PRODUCT CHANGE NOTIFICATION

PRODUCT CHANGE NOTIFICATION NUMBER: PC000017

PCN DATE: August 1, 2022

Updated label specification in-line with ECIA industry guidelines

PRODUCT CHANGE NOTIFICATION

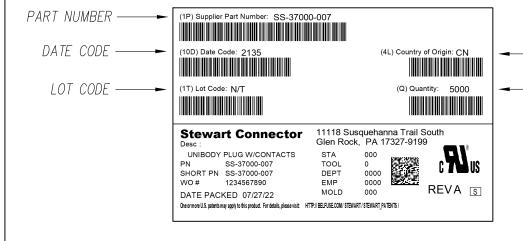
- 1. LABEL DESIGNED TO FOLLOW EIGP 114.2018 SPECIFICATION
- 2. MARKED INFORMATION HAS BEEN MOVED TO THE TOP WITH BARCODES AND TEXT
- 3. ROI PN WAS RENAMED TO SHORT PN
- 4. MATL LOT # WAS REMOVED
- 5. LOT CODE WAS ADDED AND WILL STATE N/T WHEN IT IS NOT TRACKED
- 6. 2D BARCODE WAS ADDED AND CONTAINS ALL BARCODE INFORMATION ON TOP HALF OF LABEL
